**OFFICIAL COORDINATION REQUEST
FOR NON-ROUTINE OPERATIONS AND MAINTENANCE**

COORDINATION TITLE- 17TDA01 Railroad Rail Removal

PROJECT- The Dalles Dam

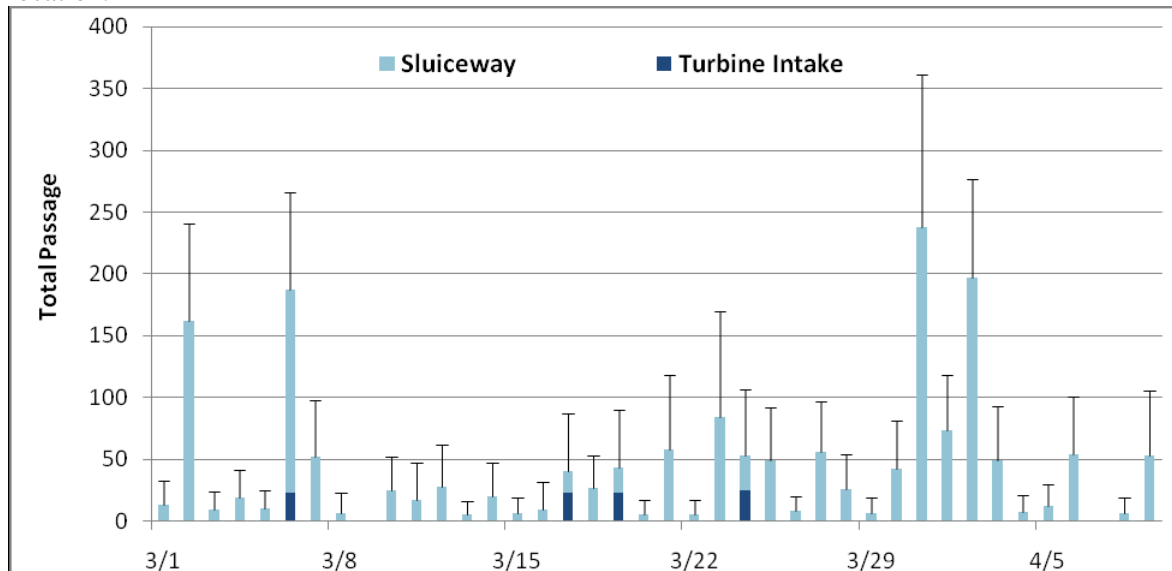
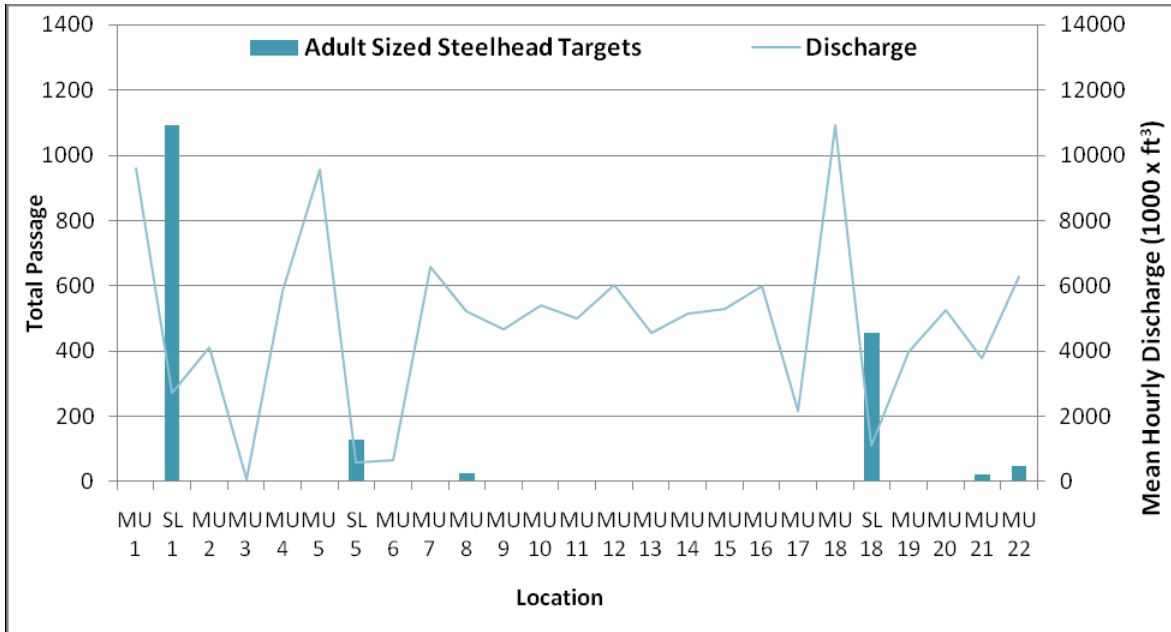
I was wondering if you could include some pictures of the train rail in the MOC. I think it would go a long way in showing just how far this work is from any of the fishways. I also noticed that you specifically mentioned fishways and exits would not be impacted. Should the word entrances be included in that sentence as well. That was creative to move around which gates are entering the sluiceway to stay within criteria. I was wondering how the 100 feet is measured? In my mind the rail is more than 100 feet away but I never broke out a tape to check. I was also wondering if we could apply some of the knowledge we picked up at LWG on impacts of sound. I have a feeling this work won't impact fish passage even if there are within the 100 threshold. -s

Derelict rail at unit 18 forebay deck. Unit 18 sluiceway gearboxes in background.

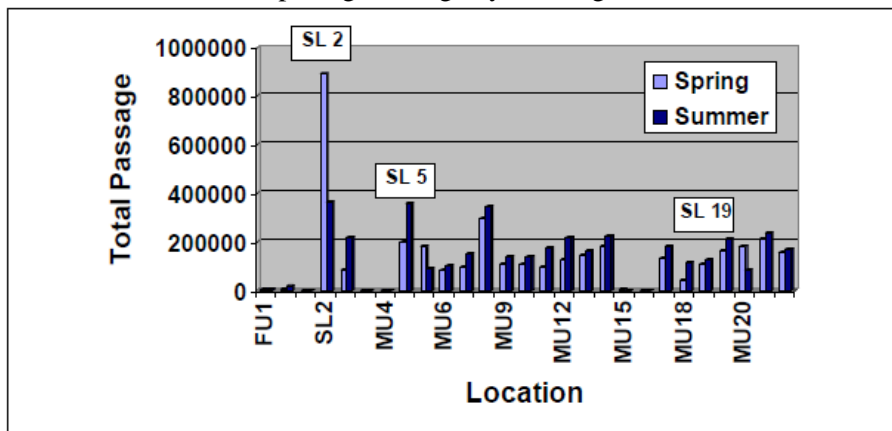
There is a potential of passage impacts to adult steelhead using the ITS for downstream passage. Operational adjustments to mitigate for this will include opening alternative units gates when work is within 100' of these entrances. Example, when work is being done near unit 1, the sluiceways will be open under unit 3. Research has shown fish will use alternative gates if open and turbine is in operation. All sluiceways will remain open as specified in Fish Passage Plan.
